No.: 04 TS – 57 (Rev.)
November 29, 2004

TO: All Distributors, Dealers, and their Branches – U.S. & Canada
ATTN.: General Manager, Service Manager
FROM: Technical Service
SUBJECT: **MBE 900 Model Year 2004 EGR Overheat Condition**

Figure 1 Restrictor Hole of Lower Thermostat Housing

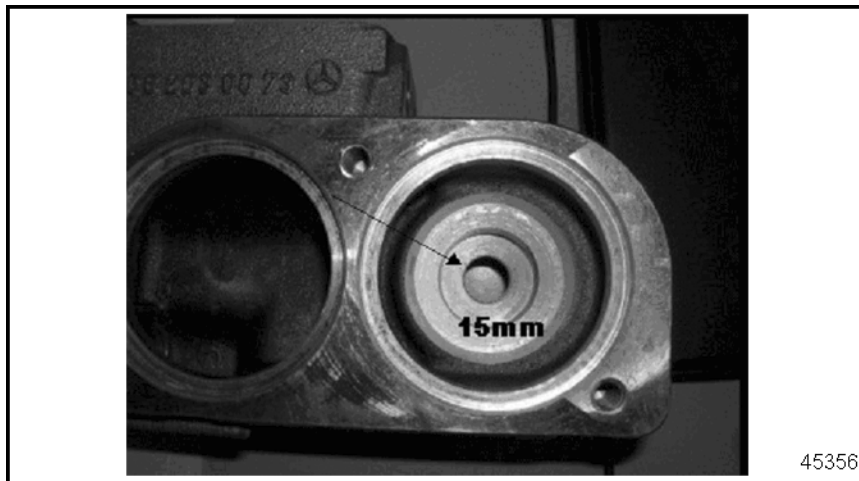
Thermostat failures were found as a result of investigating the high engine coolant temperature. The primary cause for the failures has been attributed to the lower thermostat housing being manufactured to the non-EGR specification with a 15 mm restrictor hole instead of the 30 mm restrictor hole required for EGR engines. See Figure 1.

The 2004 model year EGR units incorporate a high-output water pump that requires the lower thermostat housing to have a 30 mm bore. The increased dimension from 15 mm to 30 mm allows the engine to maintain a constant coolant temperature and reduces stress to the associated cooling system components.

The corrective action plan will be to replace the lower thermostat housing.
